UNITED STATES PATENT AND TRADEMARK OFFICE

APPLICATION NO.	FILING DATE	FIRST NAMED INVENTOR	ATTORNEY DOCKET NO.	CONFIRMATION NO.
10/765,257	01/26/2004	Valentin Botosan	706599US2	9582

Office Action Summary	Application No.	Applicant(s)	
	10/765,257	BOTOSAN ET AL.	
	Examiner	Art Unit	
	James Pilkington	3682

DETAILED ACTION

Figure 1, taken from Olsson Figure 2a

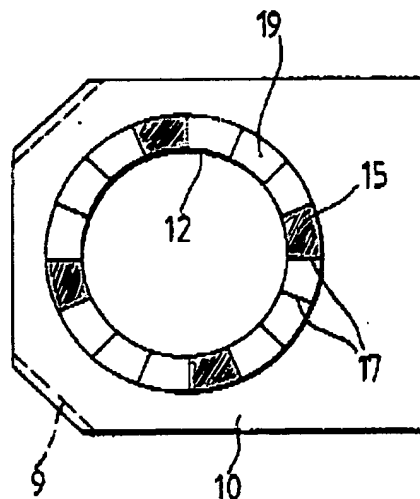
Re clm 12, Olsson discloses said first plurality of tabs (19) includes four tabs equally spaced apart along a radial inner edge of said body. (see Figure 1 below)

Re clm 16, Olsson discloses said first plurality of bendable locking tabs (19) are moveable between an engaged position contacting a head of a bolt (2) and a disengaged position retracted from said head of said bolt (2).

Re clm 17, Olsson discloses said first plurality of bendable locking tabs (19) are substantially perpendicular to said body (10) in said disengaged position and are formed at an angle relative to said body (10) in said engaged position.

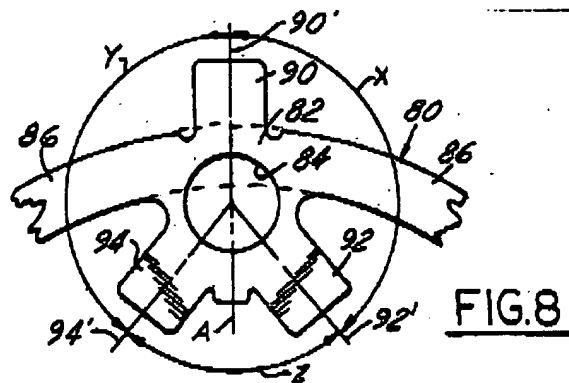
Re clm 12, Wilson discloses said first plurality of tabs (3 and 7) includes four tabs equally spaced apart along a radial inner edge of said body. (see Figure 1 below)

Re clm 16, Wilson discloses said first plurality of bendable locking tabs (7) are moveable between an engaged position contacting a head of a bolt (4) and a disengaged position retracted from said head of said bolt (4).

Re clm 17, Wilson discloses said first plurality of bendable locking tabs (7) are substantially perpendicular to said body (1) in said disengaged position and are formed at an angle relative to said body (1) in said engaged position.
